**YARRA CITY COUNCIL**

**1.1      2 Reserve Street Carlton North - Planning Permit Application PLN17/0048 - Development of the land for the construction of one, three-storey dwelling, including part demolition**

**Proposal:** Development of the land for the construction of one, three-storey dwelling, including part demolition.

**Zoning / Overlays:** Neighbourhood Residential Zone (Schedule 1)  
Heritage Overlay (Schedule 326)

DRAWING TITLE		
Existing Conditions		
PROJECT		
Proposed House Craig Guttridge & Shah Ahmad 2 Reserve St Carlton North		
SCALE	DRAWING NUMBER	
1:200	001	
REVISION	DRAWN BY	DATE
D	CG	MAR 2017

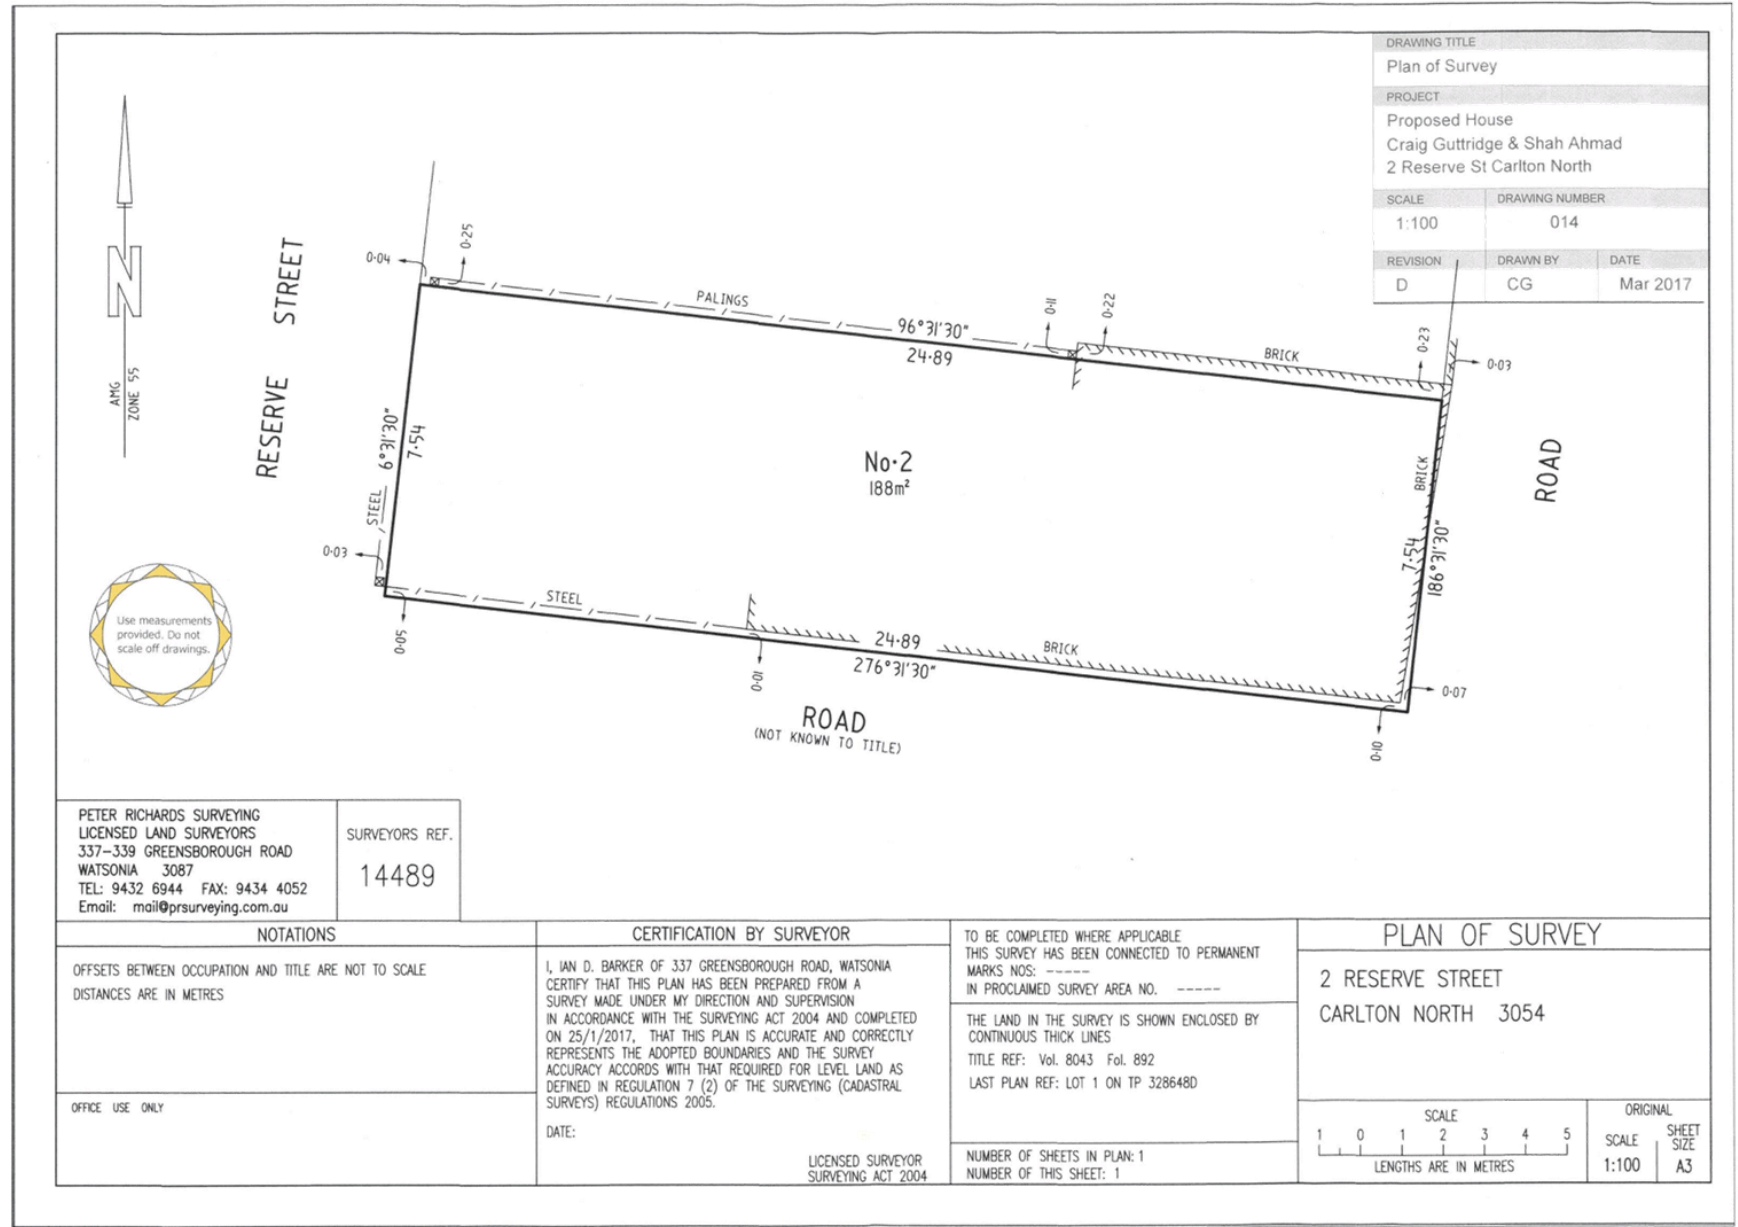
100. Currently, the existing wall along the northern boundary is 8.9m in length and varies in height between 3m to 3.6m, which meets the allowable length and height set by the Standard. However, whilst the demolition plan shows the height of this existing wall as being between 3m to 3.6m, the proposed elevations show the height of the existing wall as 3.3m.

A condition will require the exact height to be clarified on both plans. The northern boundary currently abuts a 1.5m wide, south-facing walkway of No. 6 Reserve Street, including a 3.5m wide habitable room window (appears to be a living-room) followed by SPOS. A condition will require this window to be shown on all plans.

DRAWING TITLE		
Proposed First Floor		
PROJECT		
Proposed House		
Craig Guttridge & Shah Ahmad		
2 Reserve St Carlton North		
SCALE	DRAWING NUMBER	
1:100	005	
REVISION	DRAWN BY	DATE
D	CG	Mar 2017

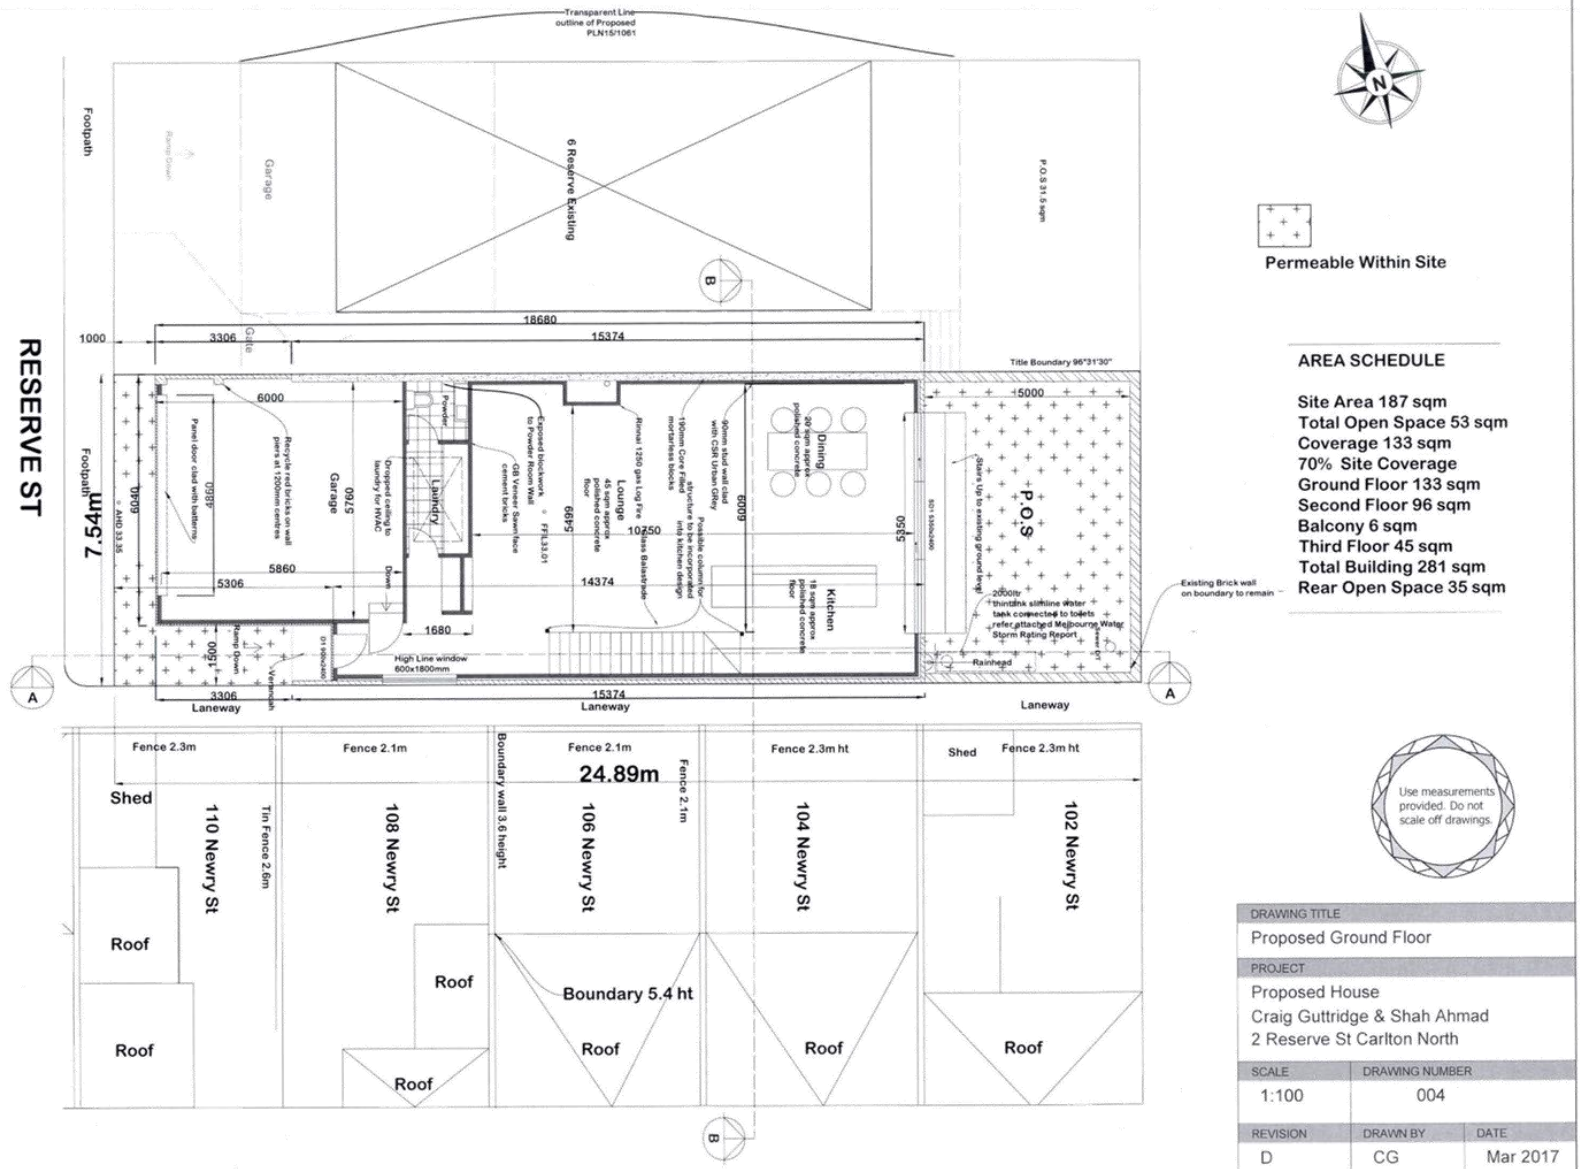
140. The proposed first floor plan shows a highlight, south-facing window to the television room; however the corresponding elevation does not show this window. However, the sectional drawing lodged as part of the sketch plans show this window at first floor (to the family room) as appearing to have a sill height of up to 1.7m above floor level. A condition will require this to be clarified given the potential for overlooking opportunities from this window to the POS of the dwellings to the south.

142. The proposed east-facing window of the bathroom at first floor does not require screening as this is not a habitable room window.
143. The master-bedroom will consist of an east-facing window and a balcony, which will consist of a 1m high balustrade. The sectional drawing submitted by the Applicant illustrates that downward views into the SPOS of Nos. 661 to 667 Drummond Street from the new balcony at first floor, are restricted to over 3.6m above natural ground within the 9m overlooking arc, as a result of the existing 3.6m high eastern boundary wall; therefore complying with the objective of the Standard. However, there is still possible overlooking opportunities into the SPOS of No. 6 Reserve Street and the SPOS of Nos. 102 and 104 Newry Street. Therefore, a condition will require for the demonstration of compliance with this Standard.

144. The sketch plans provided show a north-facing window to the family/living area (adjacent to the proposed light-court). The first floor plan states that this window will have a sill height of up to 1.7m above floor level; and as such complying with the Standard. The sketch plans also show a west-facing window (adjacent to the light-court) to the bathroom. Given that this is not a habitable room window, screening is not required.

- (k) The following to demonstrate compliance with the objective of Standard A15 (Overlooking objective) of Clause 54 of the Yarra Planning Scheme:
    - (i) South-facing family room window and south-facing staircase window at first floor;

# Attachment 3 - PLN17/0048 - 2 Reserve St - Updated Shadow Diagrams

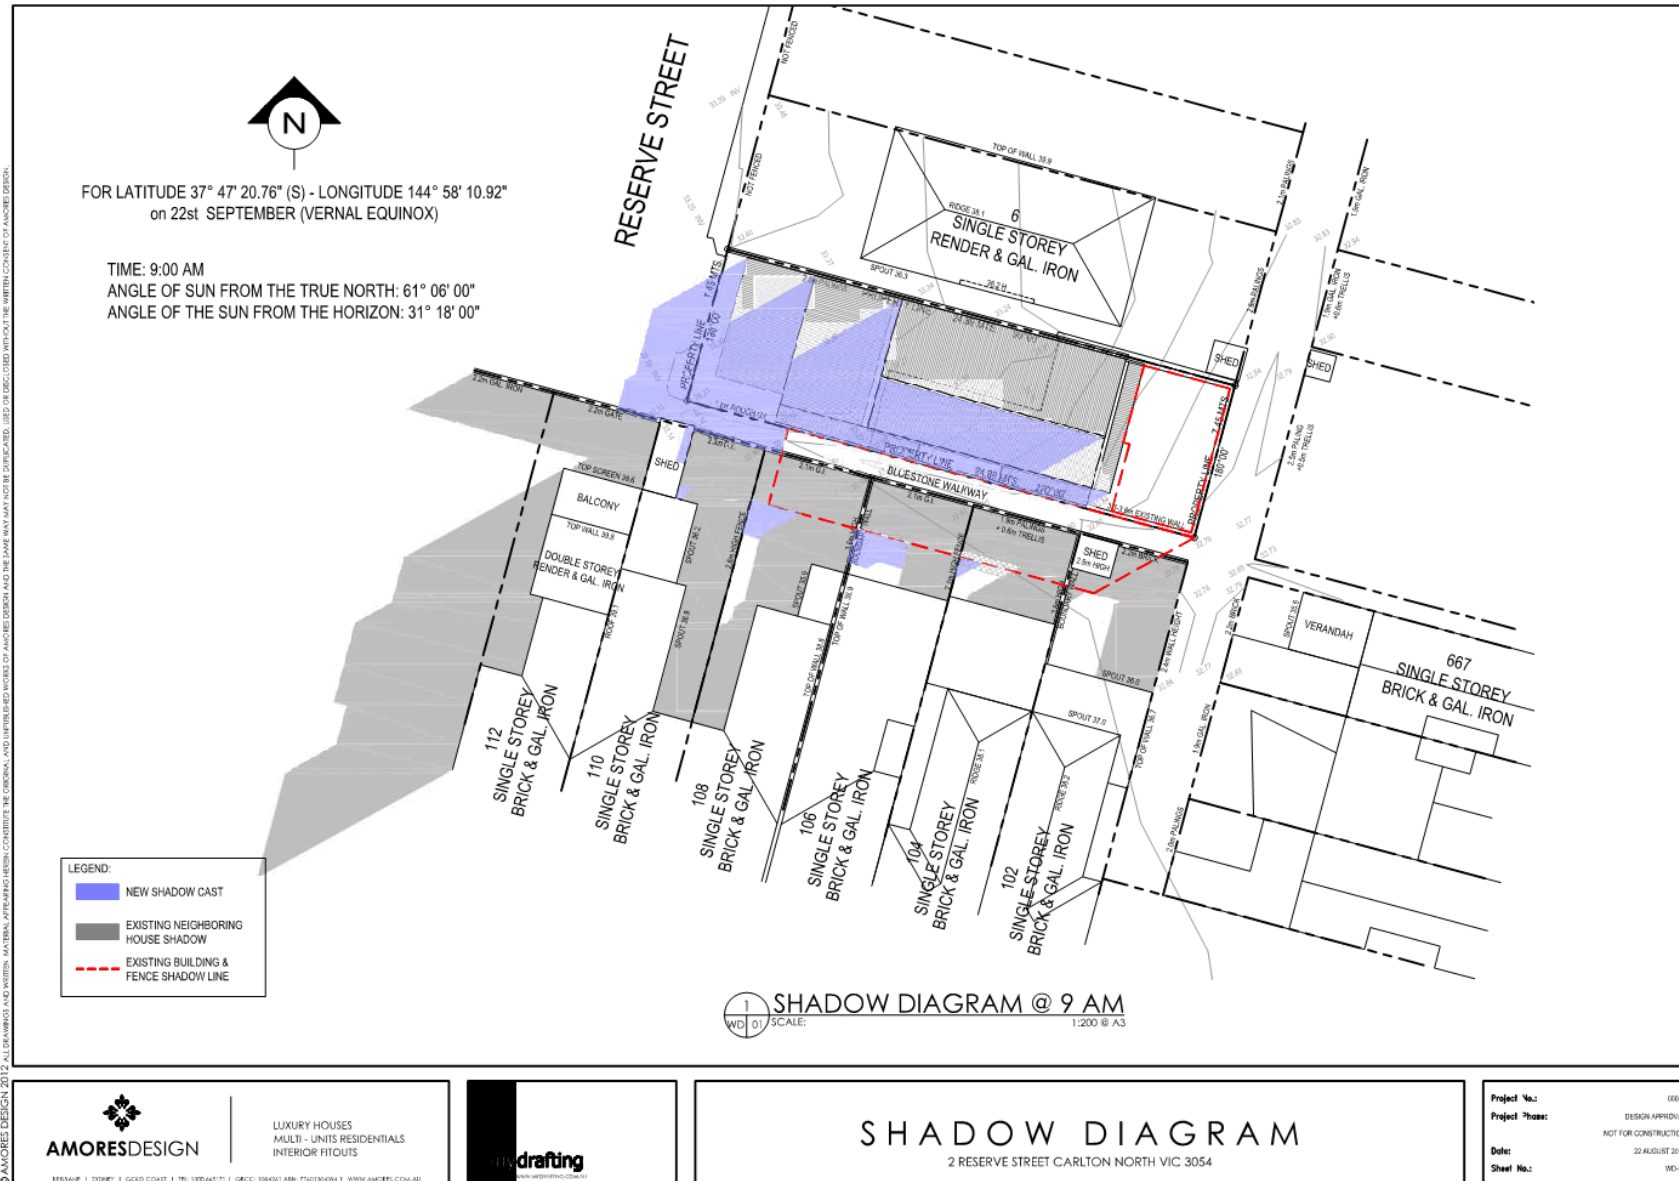
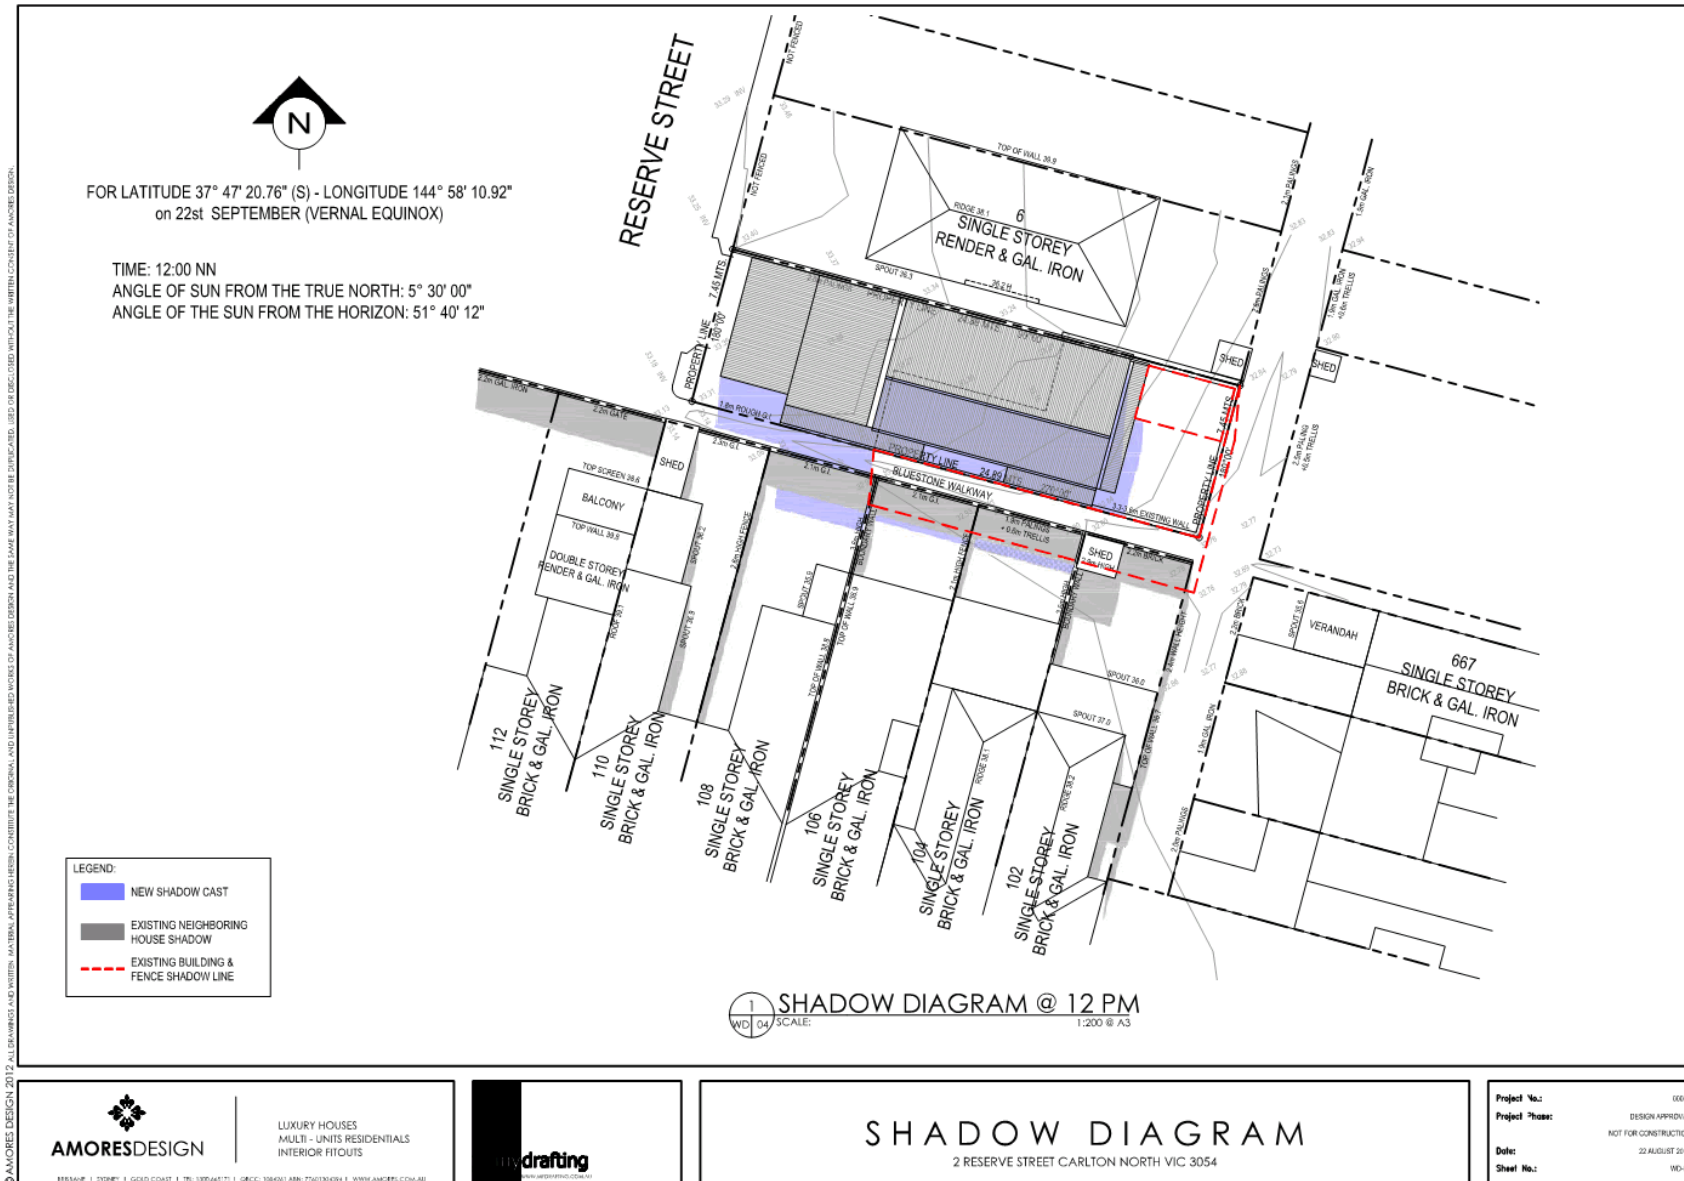
Time	Shadowed (Existing) SPOS	Unshadowed Area (Existing) SPOS	Shadowed (Proposed) SPOS	Unshadowed (Proposed) SPOS	Increase in Overall Shadows
9am	34.6sqm	0.4sqm	35sqm	0sqm	0.4sqm
10am	32sqm	3sqm	32.9sqm	2.1sqm	0.9sqm
11am	26.2sqm	8.8sqm	27.7sqm	7.3sqm	1.5sqm
12 pm	10sqm	25sqm	Not impacted	Not impacted	No change
